PRELIMINARY DRAINAGE REPORT

RISING MOON FILING NO. 1
(A Replat of Tract B, Morning Sun I)

PCD Filing No.: XXXX  **SP243**

**EXISTING CONDITIONS
DRAINAGE MAP**

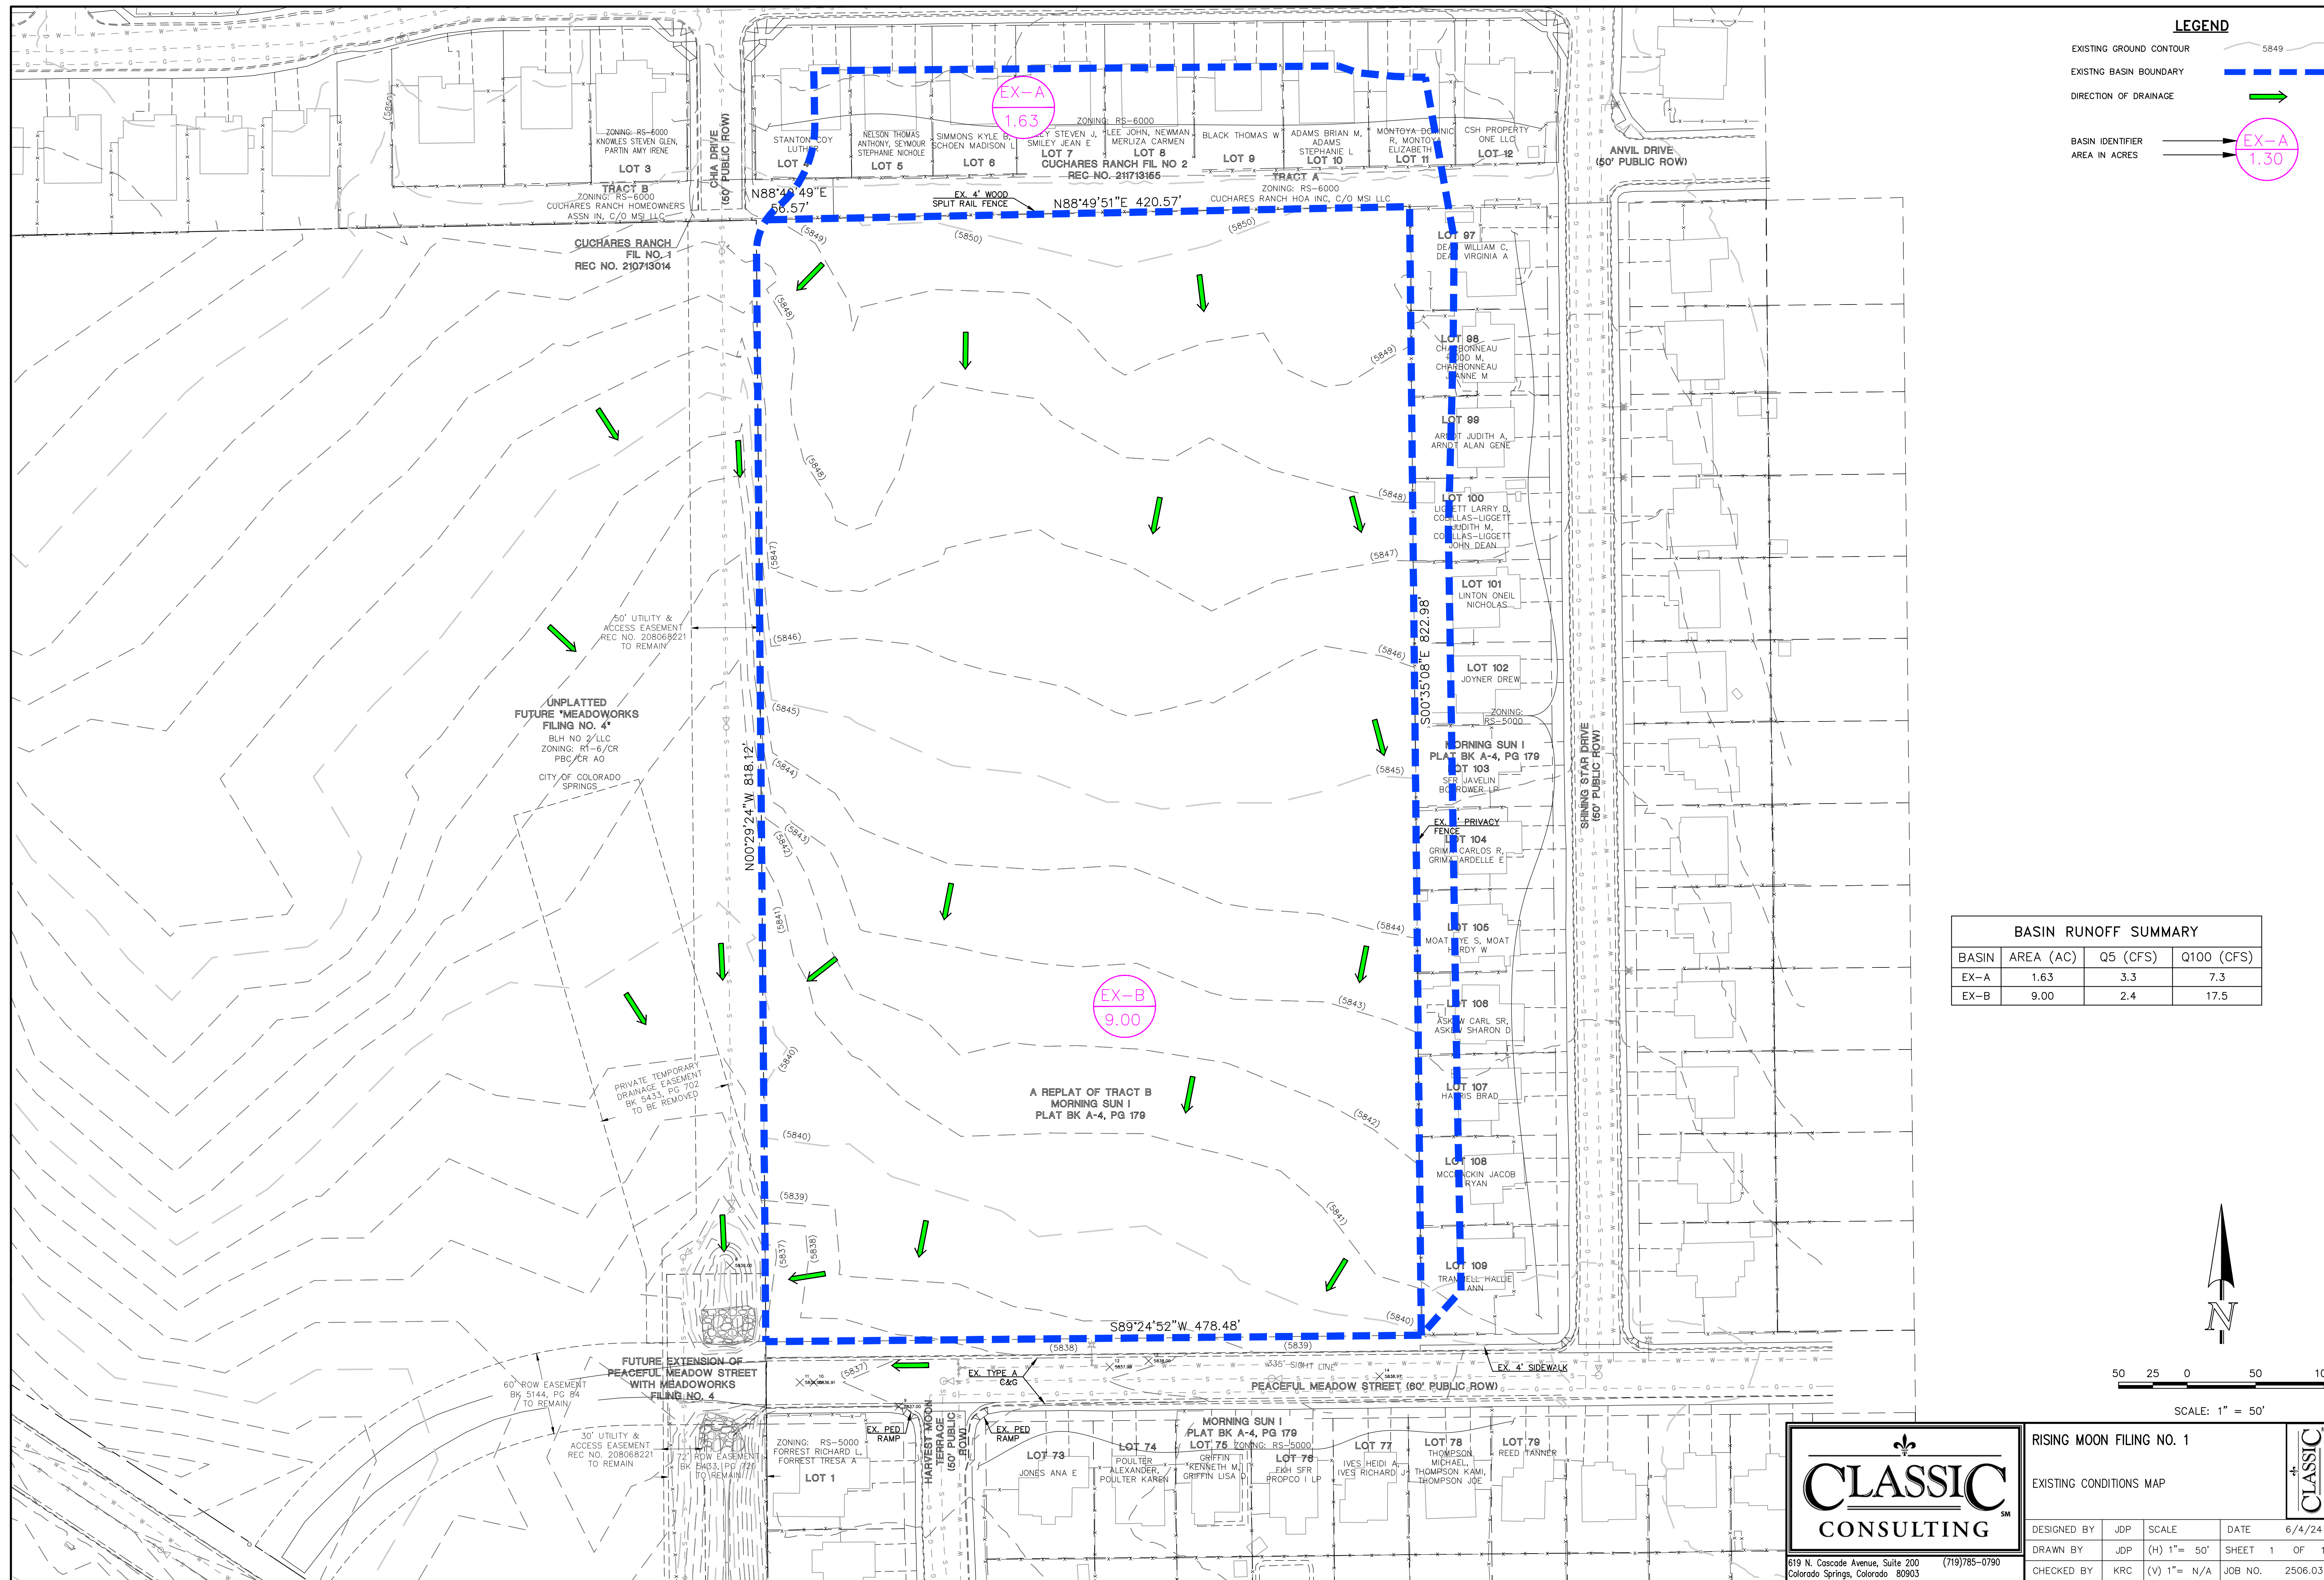
Include design points on the both the existing conditions and proposed maps

PROPOSED CONDITIONS

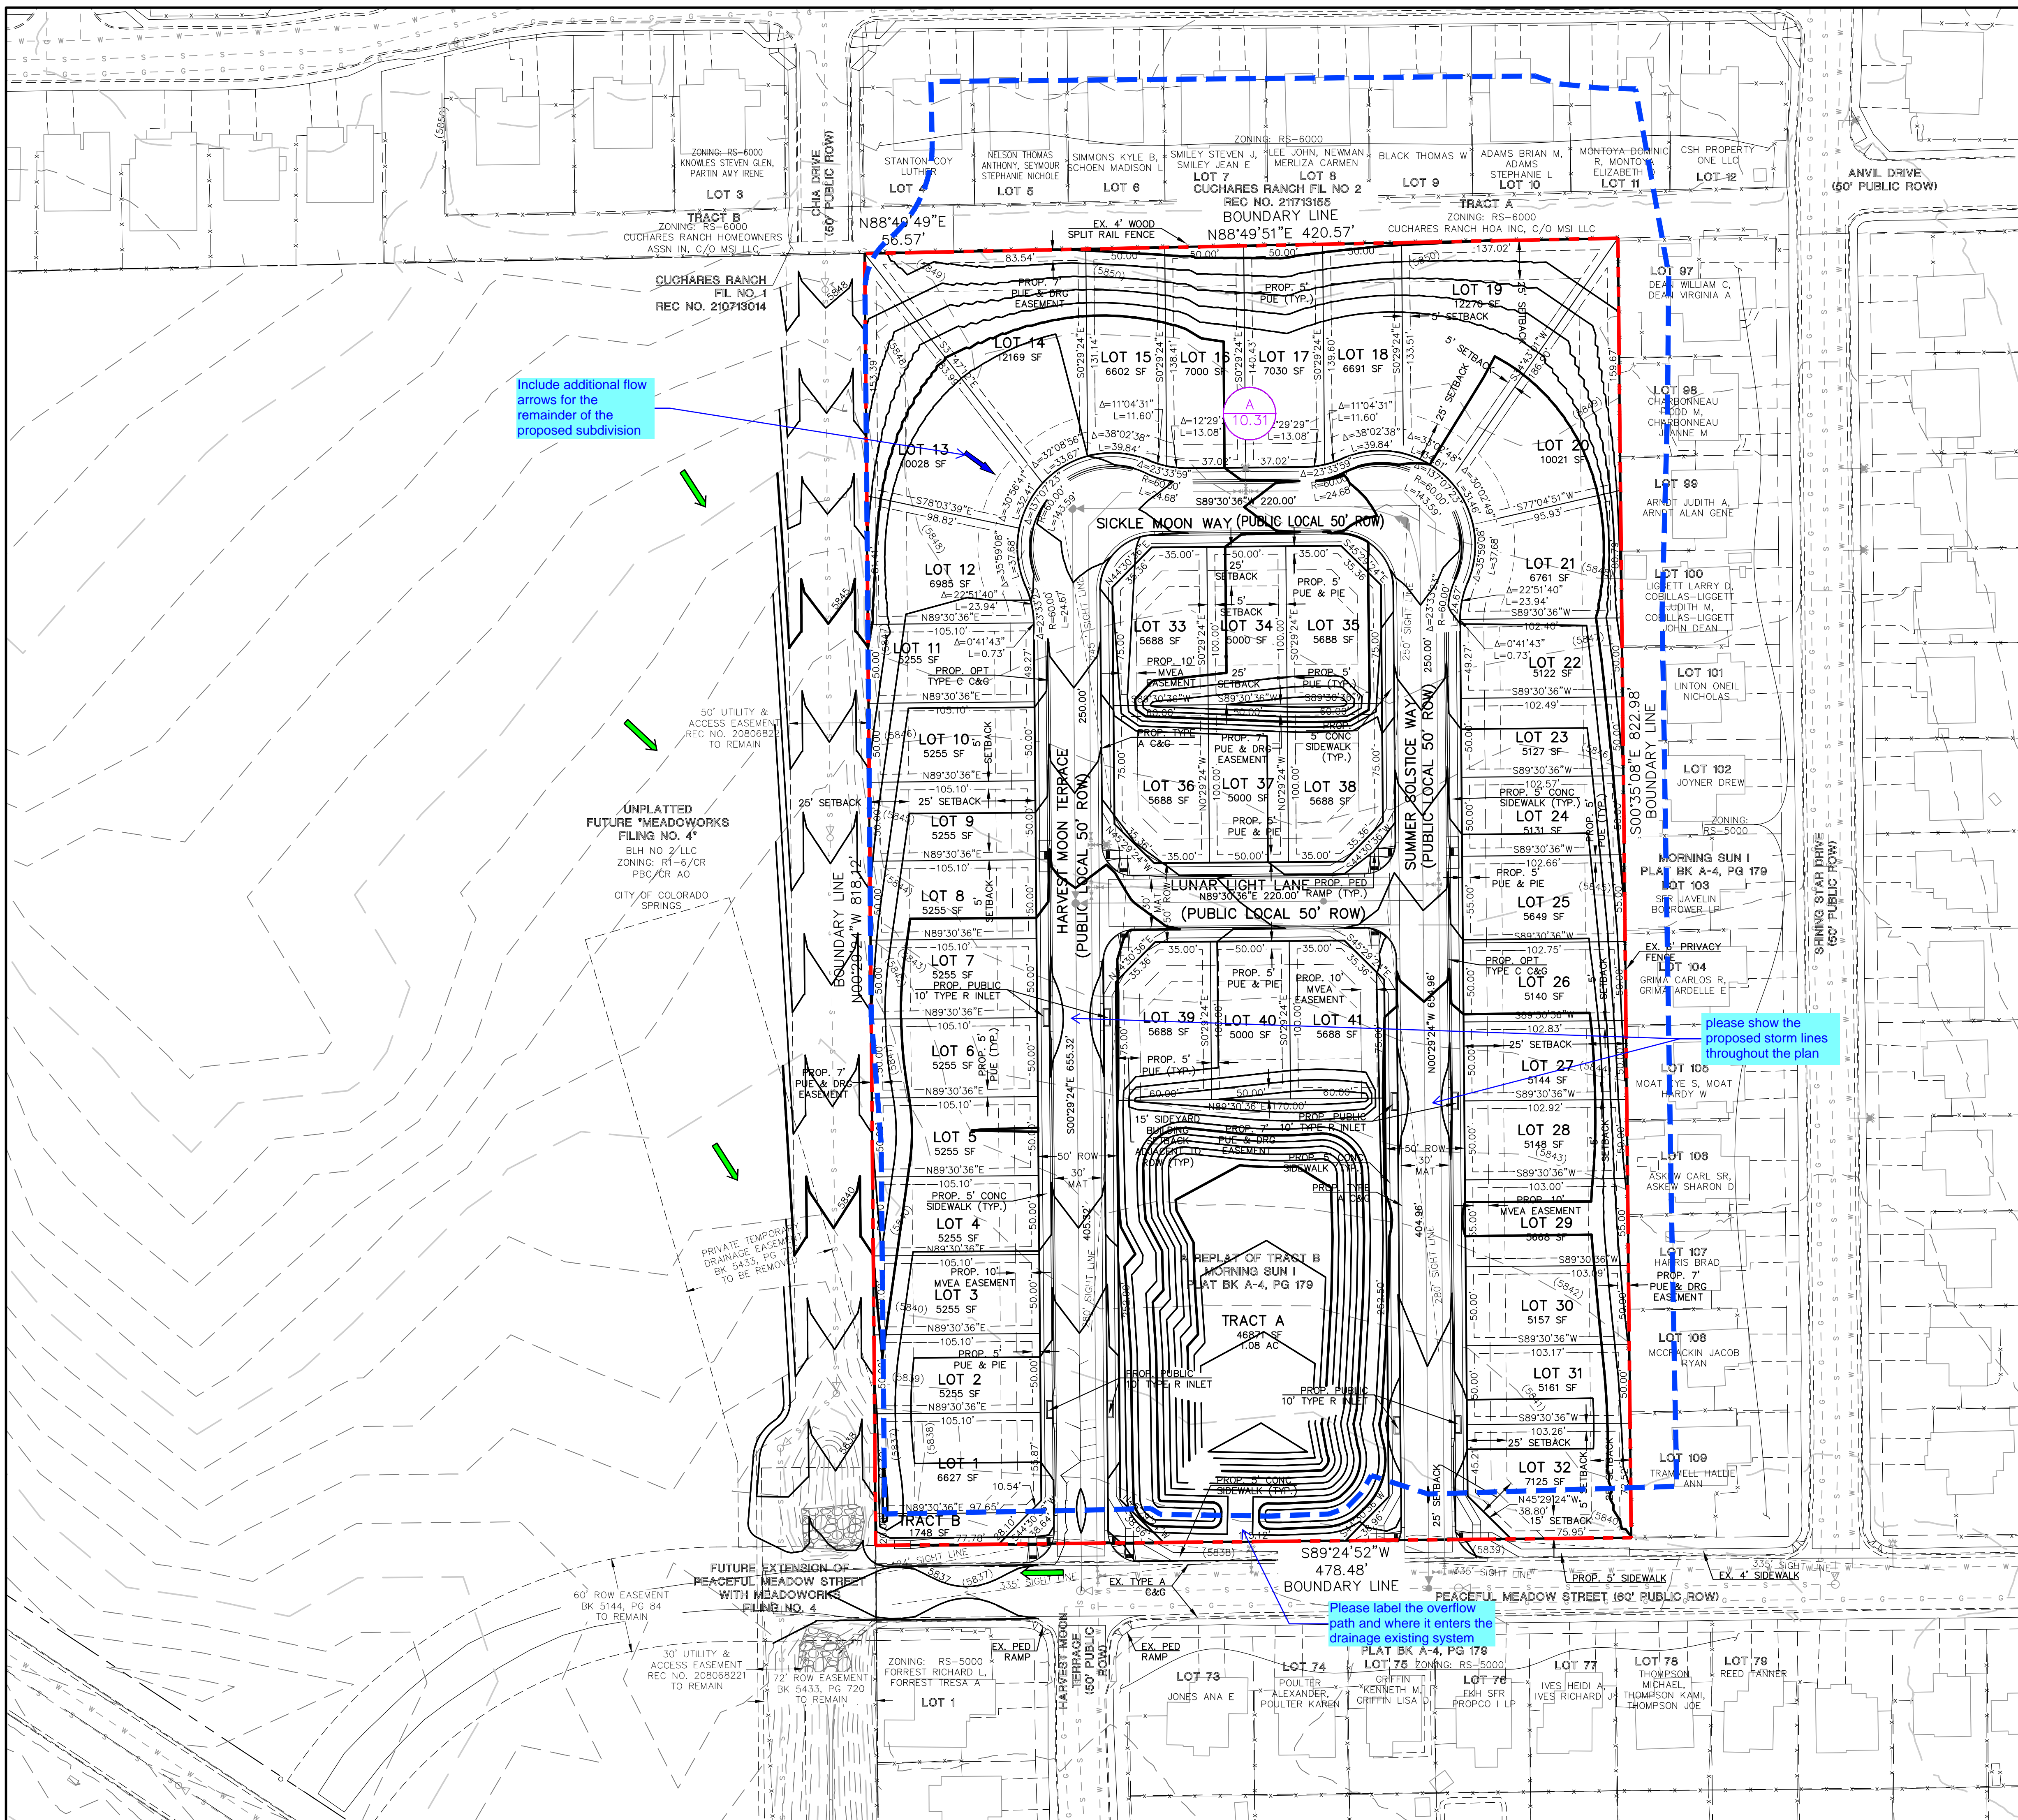
Please include culvert pipes and outfall on the map.
